This Service Information bulletin supersedes SI 34 08 14 **dated July 2015**.

Ticking Noise from Front Axle When Cornering

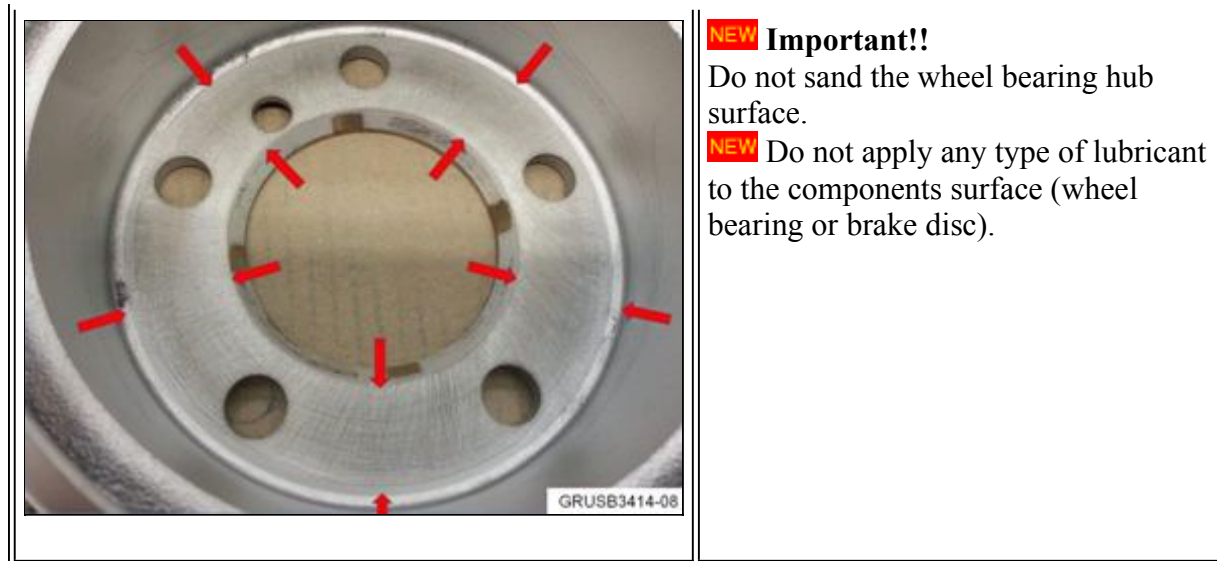
The customer may complain of a ticking noise from the front axle when cornering, maneuvering, parking or pulling away from a parking space. The noise can be heard as a light metallic ticking from the front outer cornering wheel.

Movement between the brake disc and wheel bearing hub.

Remove and clean the front axle brake discs.

NEW Using 80-grit sandpaper, sand the contact surface of the **brake disc** to the wheel bearing hub.

NEW Sand the surface in a radial motion (inside to outside around the surface).

NEW Clean the wheel bearing hub surface with brake cleaner.

Do not sand the wheel bearing hub surface.

NEW Do not apply any type of lubricant to the components surface (wheel bearing or brake disc).

Reinstall the front axle brake discs.
